Docket Number 50-346

Subject: Request for Additional Information Regarding Root Cause Analysis Report
(TAC No. MC1642)

By letter dated March 4, 2004, the NRC staff issued a request for additional information concerning the Davis-Besse Nuclear Power Station Unit Number 1 (DBNPS) technical Root Cause Analysis Report, "Significant Degradation of the Reactor Pressure Vessel Head". This report was first submitted to the NRC by the FirstEnergy Nuclear Operating Company (FENOC) under letter Serial Number 1-1270, dated April 18, 2002, and Revision 1 of the report was later submitted under Serial Number 1-1289, dated September 23, 2002. The following provides FENOC's responses to the NRC's request for additional information.

Davis-Besse Top of Reactor Head

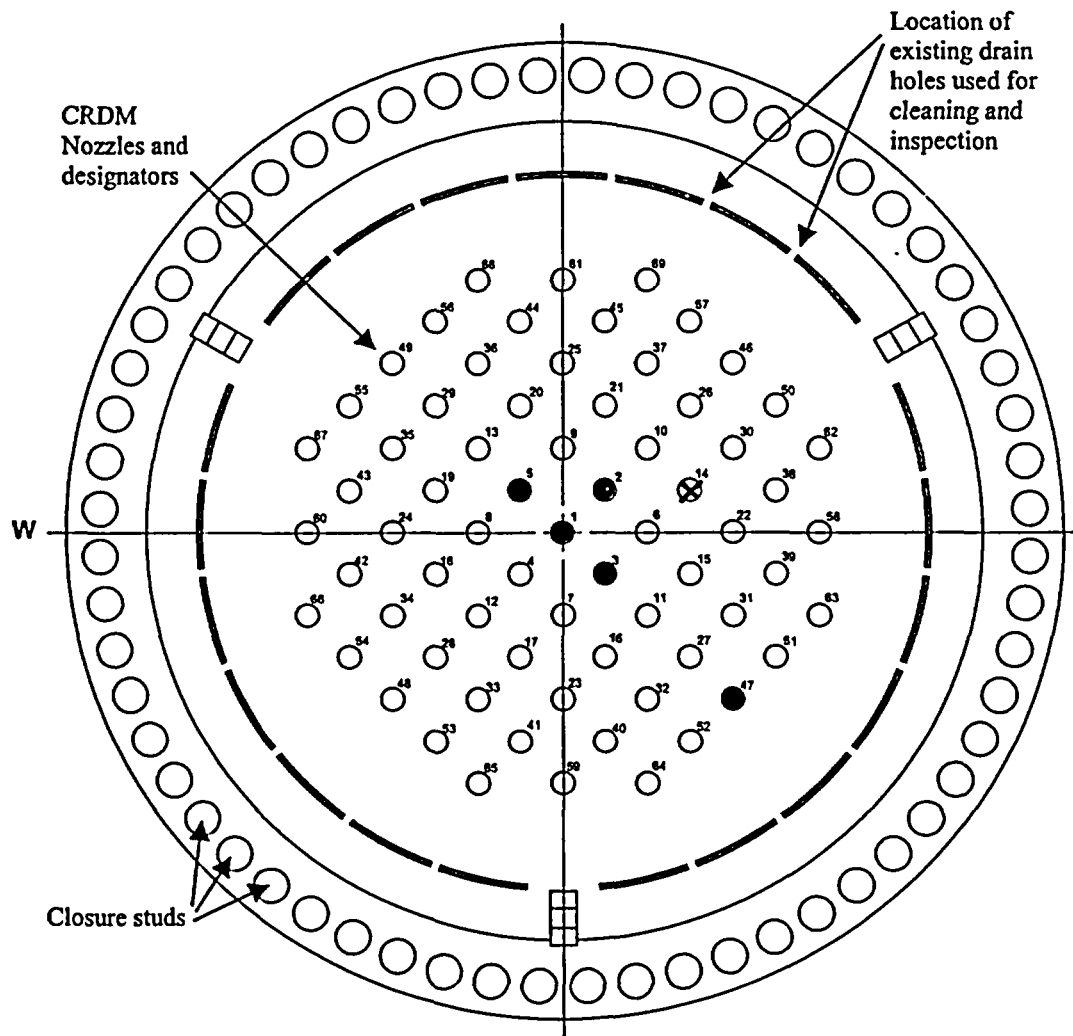
The purpose of the vent line that runs from nozzle 14 to the steam generator number 2 upper primary hand hole is to vent non-condensable gases from the Davis Besse reactor pressure vessel (RPV) head during a loss of coolant accident. The head vent configuration at Davis Besse is unique from other Babcock and Wilcox (B&W) designs in that reactor coolant flows continuously through it during power operations. Given the proximity of the cracked nozzles in the old RPV head to the vent line nozzle, a phenomenon may exist wherein the continuous flow through the vent line impacts the potential for cracking of nearby nozzles. This same phenomenon, if real, could impact the cracking assumptions for the new RPV head.

Confirm whether or not you considered this potential phenomenon in the April 2002 root cause analysis that was performed as a result of the degradation of the old RPV head. If an evaluation was performed, provide the results of the technical analysis that would demonstrate that the phenomenon either did or did not impact cracking in adjacent nozzles. If this potential phenomenon was not considered, provide the technical basis for discounting it. If it was not discounted, but it was never considered, provide a technical basis for why it will or will not play a role in the operation of the new RPV head. If your analysis results show that there is a potential impact on the new RPV head penetrations, discuss the actions that would be taken to ensure the integrity of the head penetrations. Consider whether an update to your root cause analysis report is needed.

The potential effect of the reactor vessel continuous vent line on increasing the likelihood of nozzle cracking was discussed in Section 3, Data Analysis, of the technical Root Cause Analysis Report (page 12 of revision 0, dated April 15, 2002, and page 15 of revision 1, dated August 27, 2002). Its effect was considered along with other differences of the DBNPS nozzles, such as operating temperature, counterbores, material susceptibility to primary water stress corrosion cracking (PWSCC), and range of interference fits. The potential effect of the reactor vessel continuous vent line was evaluated based on established facts of damage to other nozzles. Among these were:

1. Automated ultrasonic examinations of all 69 Control Rod Drive Mechanism nozzles were performed from beneath the Reactor Pressure Vessel (RPV) head. As reported on page 6 of the technical Root Cause Analysis Report, nozzles 1, 2, 3, and 5 all exhibited flaws. This meant that 4 of the 5 nozzles from Heat M3935 had flaws, and they were all clustered at the top of the head, not around the continuous vent line's nozzle 14 (see attached figure from the technical Root Cause Analysis Report). As discussed on page 16 of the technical Root Cause Analysis Report, Heat M3935 has exhibited a higher PWSCC susceptibility in the industry.
2. The only nozzle with flaws that was somewhat proximate to nozzle 14 itself was nozzle 2.

3. The only other nozzle with a confirmed flaw was nozzle 47, which is on the perimeter of the head, quite some distance from nozzle 14.
4. Overall, it was determined that the head temperatures were sufficiently high to support the initiation of cracks due to PWSCC.

Accordingly, the technical Root Cause Analysis Report concluded the effect of the continuous vent line on the nozzles was very small.

would have no effect on the conclusions of the report. The potential for the continuous vent line to have caused the flaws in nozzles 1, 2, 3, 5, and 47 was considered during the technical root cause analysis. It was concluded that this potential was very small, as documented on page 15 of revision 1 to the report. Therefore, no revision to the technical Root Cause Analysis Report is necessary.
